Northern Link Road Tunnel Project

## **Application for Project Change**

October 2010

Figure 2-42: Eastern worksite – Stage 1, 2 & 3 layout

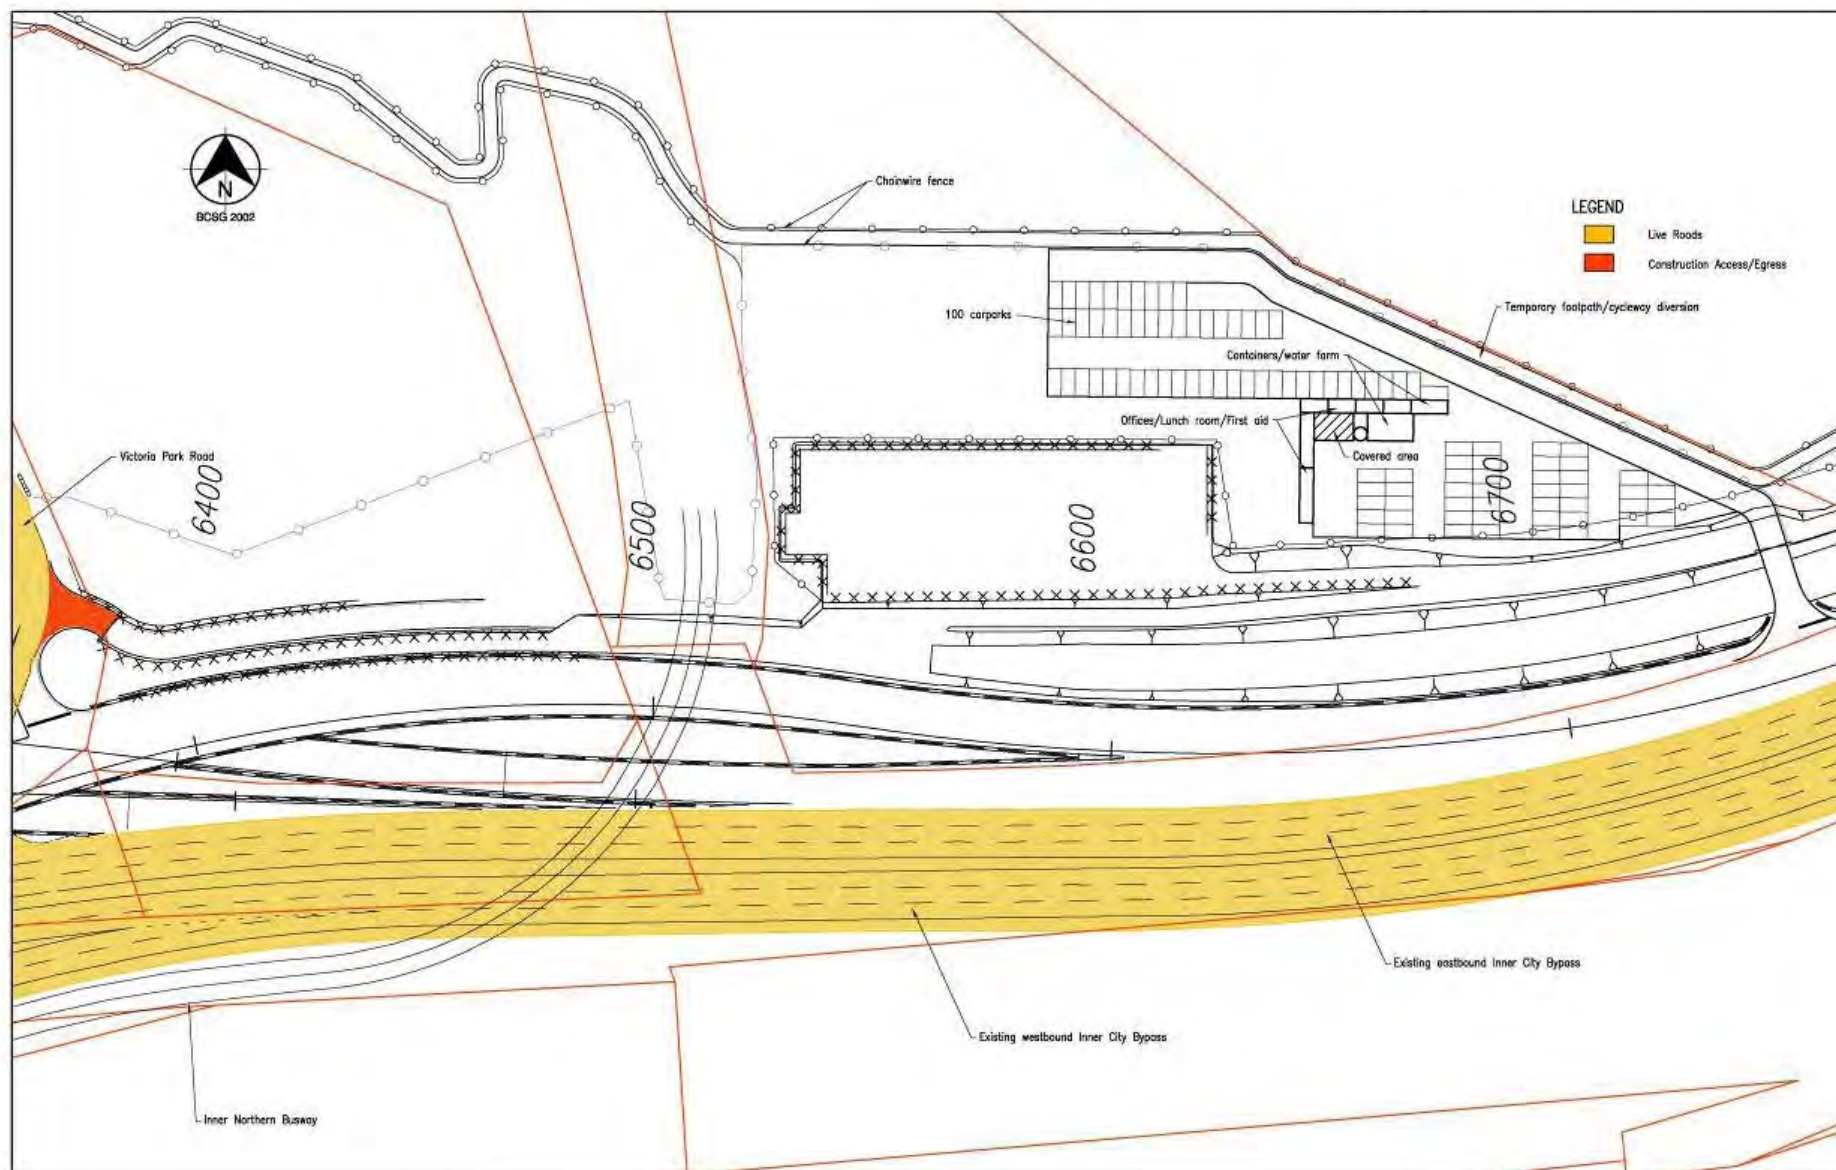
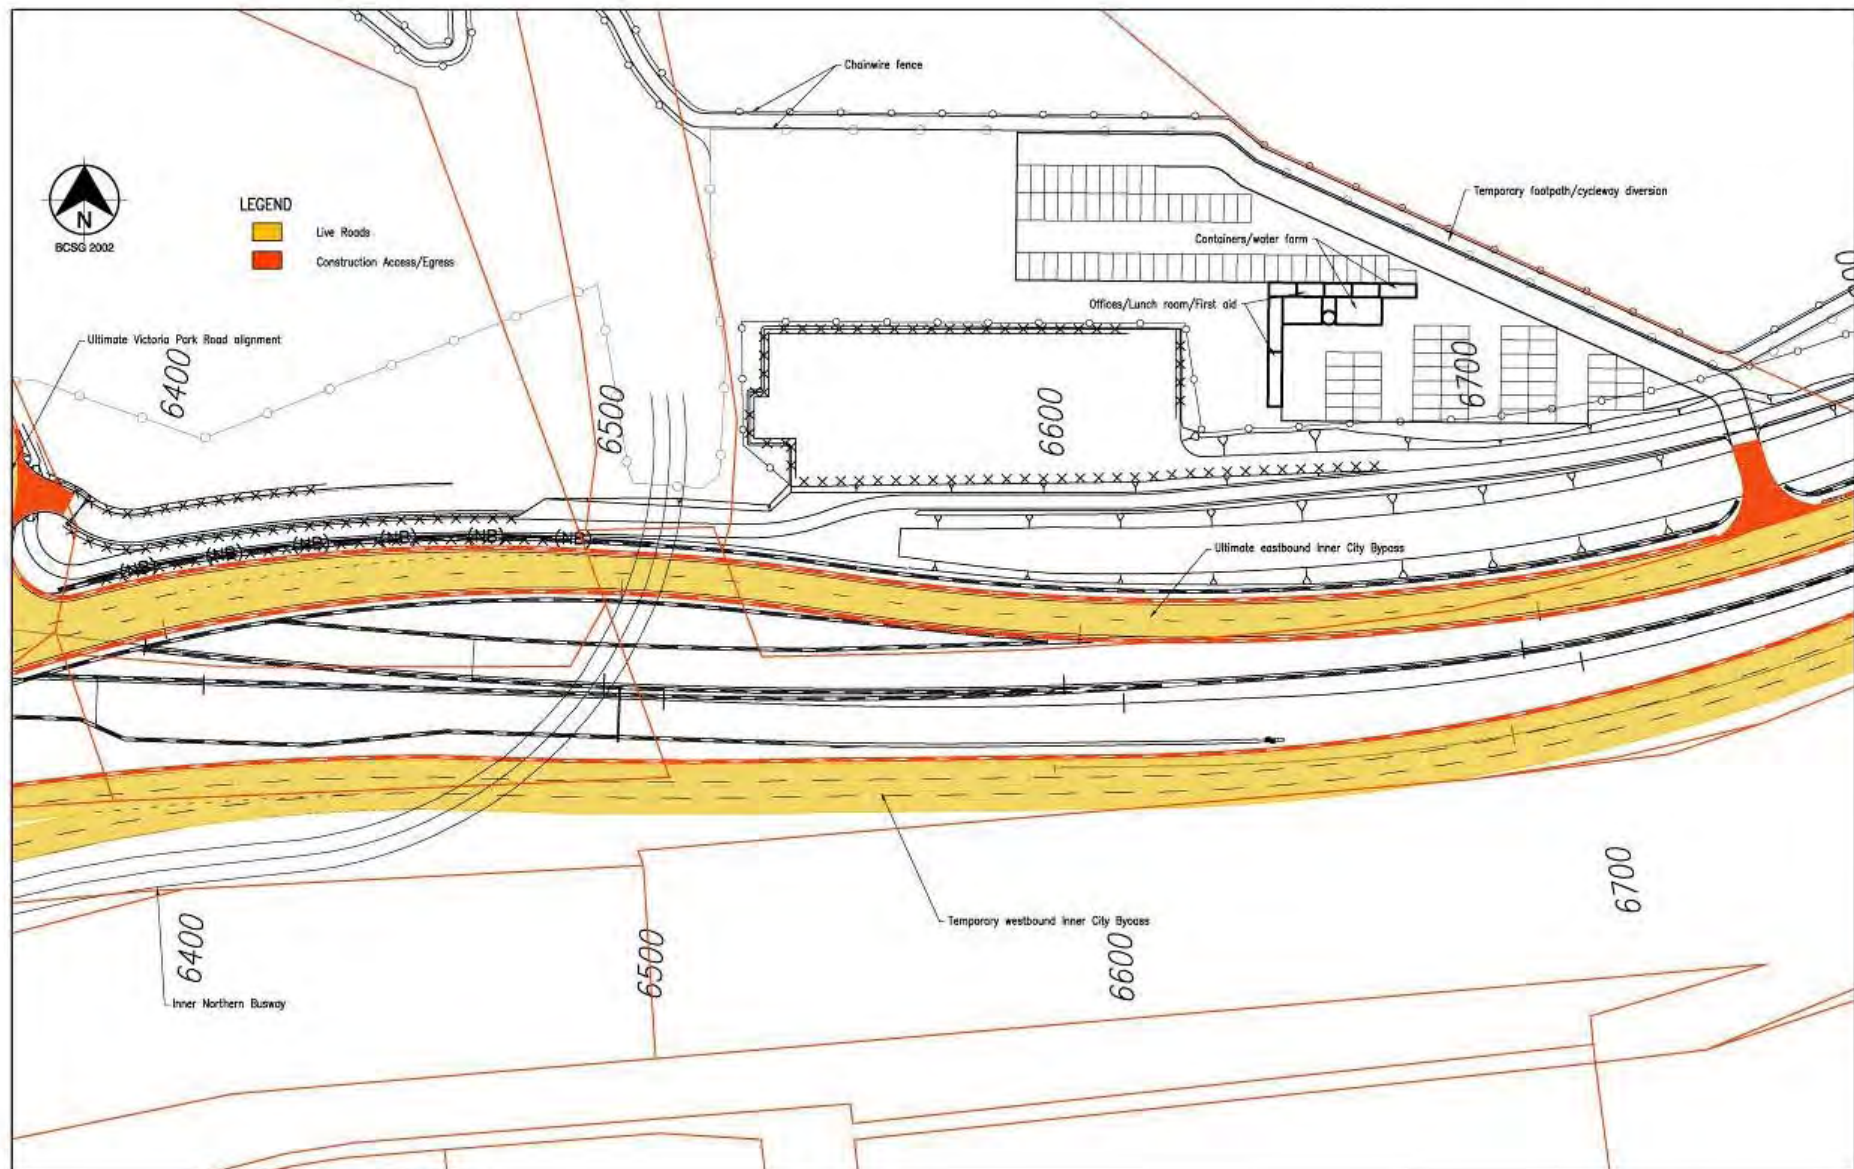
- the TBM portal and cut and cover area below Normanby Terrace required to extract the TBMs as proposed in the Reference Design (**Figure 2-44**);
- an enlarged area of the Brisbane Grammar School playing fields required to realign Victoria Park Road over the completed cut and cover works, realign the ICB eastbound lanes and also realign the major drainage channel north of the ICB (**Figure 2-42** and **Figure 2-43**);

- the construction through the northern abutment of the INB to provide the additional bridge span for the realigned ICB lanes, drainage and final shared path alignment (**Figure 2-42** and **Figure 2-43**);

- as with the Reference Design, an area in Victoria Park required for site facilities including construction car parking, offices and utility areas (**Figure 2-42** and **Figure 2-43**).

Figure 2-48: Change Project – Spoil conveyor route and stockpile design

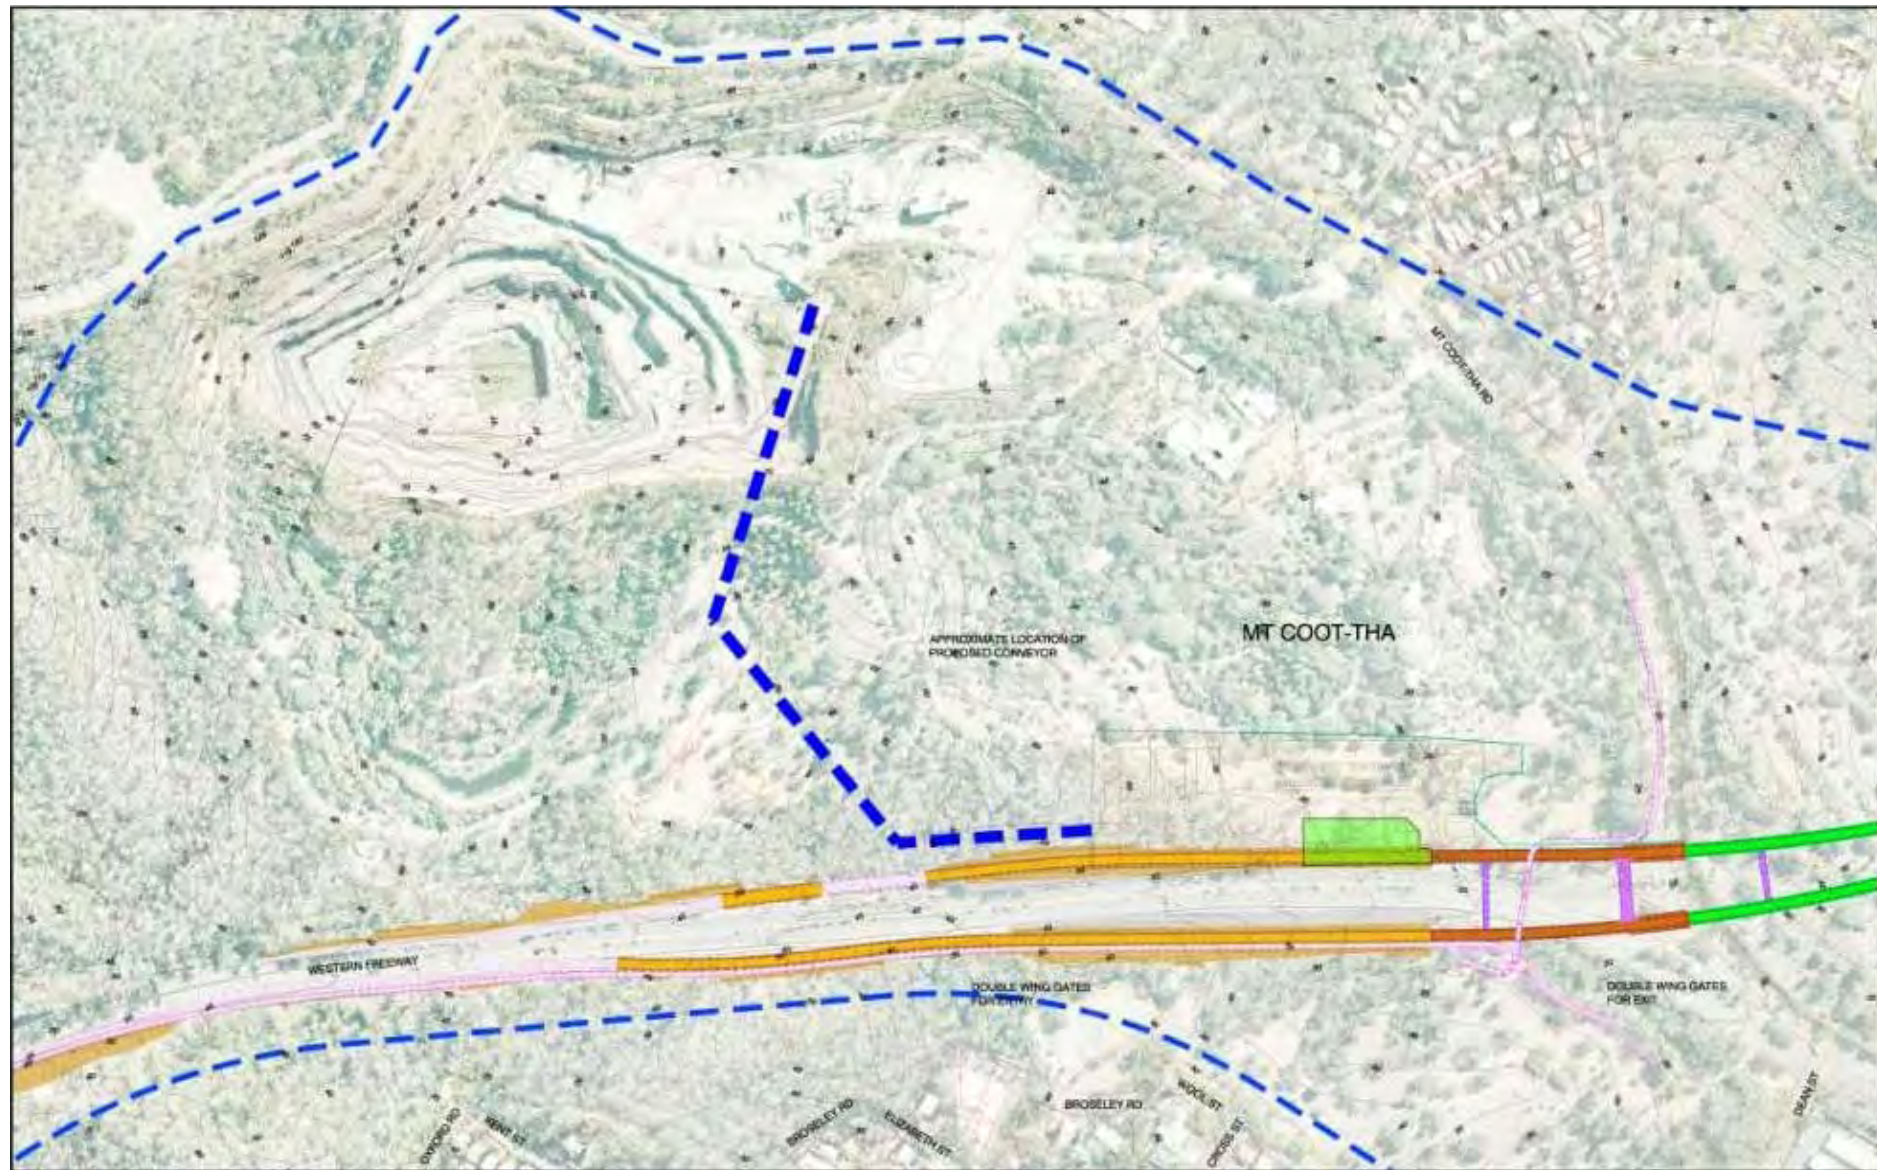
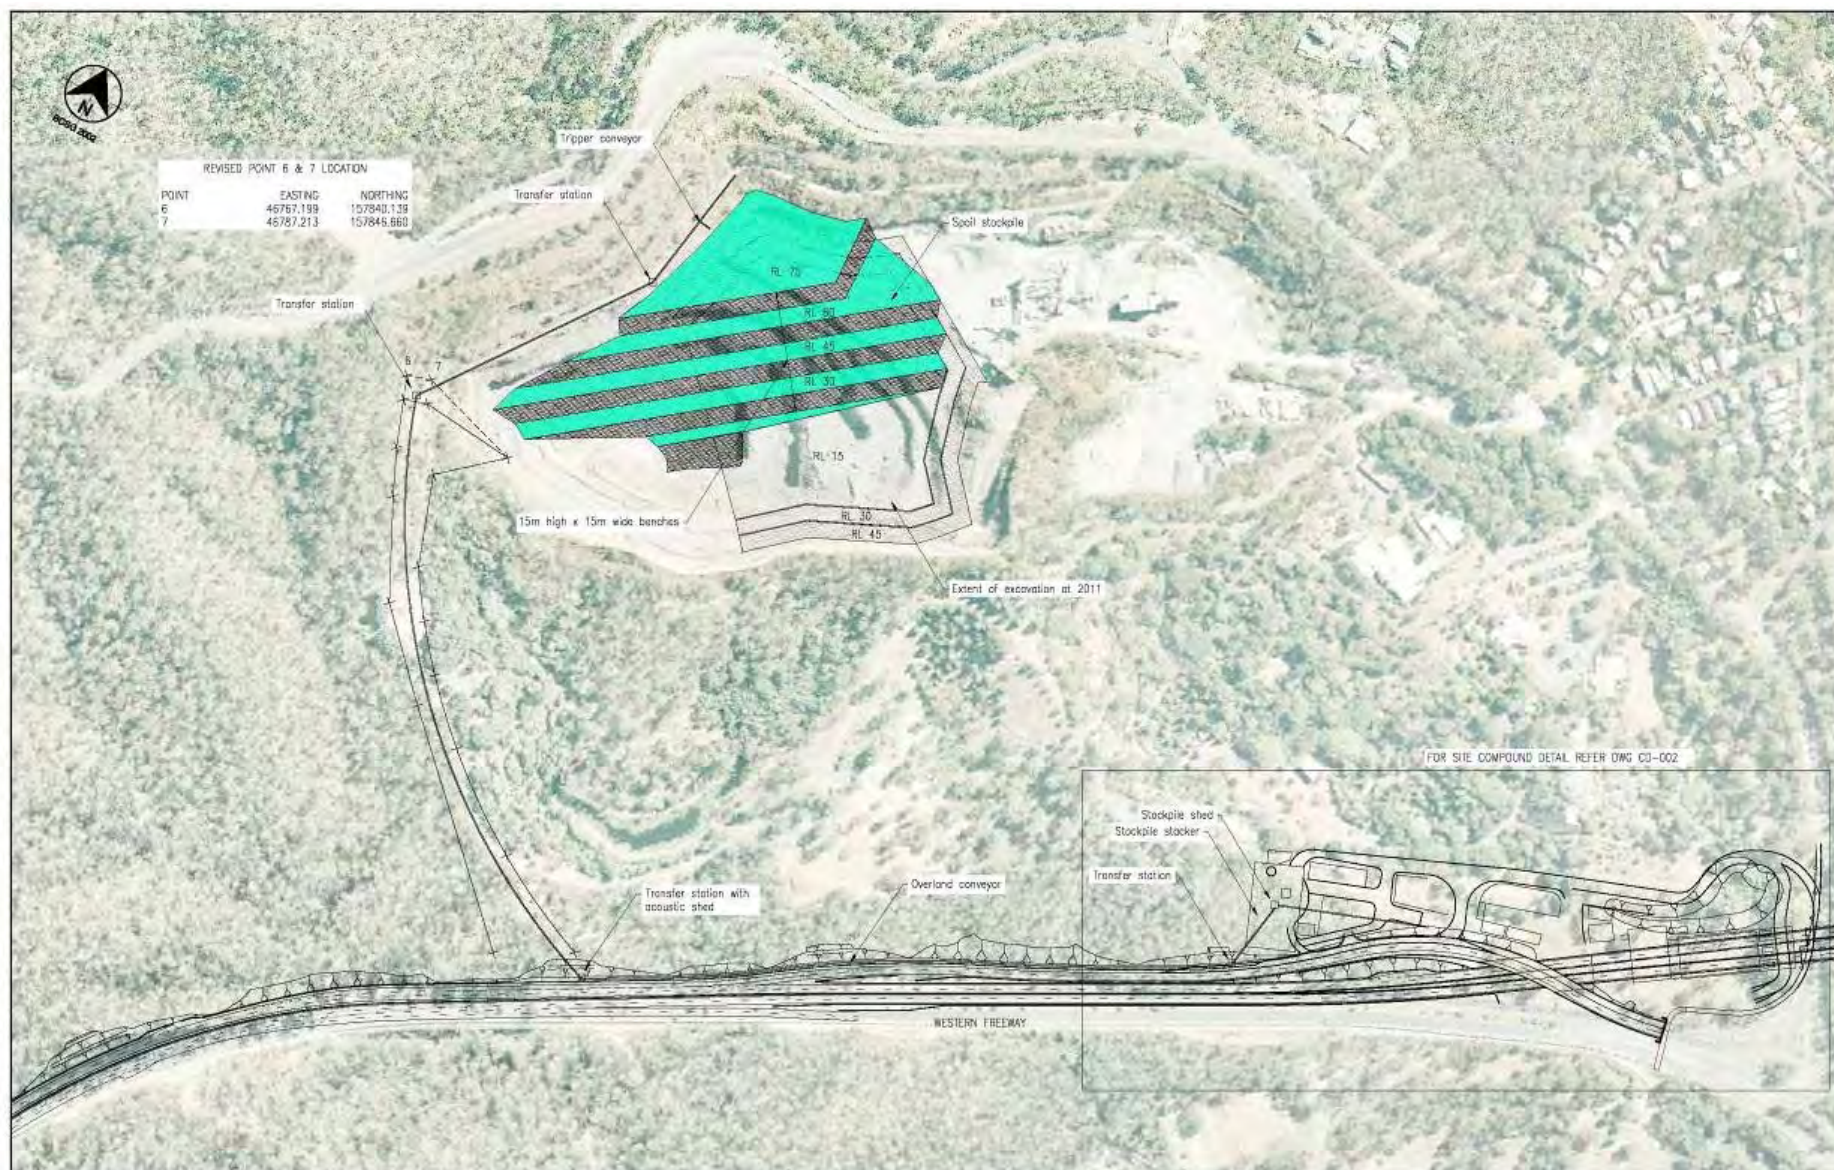
The spoil conveyor from the worksite into the quarry would follow a different alignment to that proposed in the Reference Design. The changed alignment would be further to the west, following earthworks for the realignment of the Centenary Motorway and to avoid public areas and plantings within the Botanic Gardens.

The conveyor route to the quarry has changed as shown on **Figure 2-48**. The length of the conveyor for the Changed Project would be approximately 1,500m or approximately 500m longer than that for the Reference Design. The first 630m of the conveyor alignment from the workshop would be within the earthworks required for the future third lane on the realigned Centenary Motorway. This land is required for the future road widening by DTMR and would be returned as landscaped and stabilised road earthworks. Approximately 550m of the conveyor alignment would pass between the Centenary Motorway through the Mt Coot-tha Forest along the western boundary of the Botanic Gardens, to the quarry. For the Reference Project, this alignment was initially through Council owned land within the Botanic Gardens and then also through State owned land identified as the Mt Coot-tha Forest, but used for the Botanic Gardens and also the Mt Coot-tha Quarry. The proposed alignment was amended by Council to specifically avoid the public areas and established plantings within the Gardens.
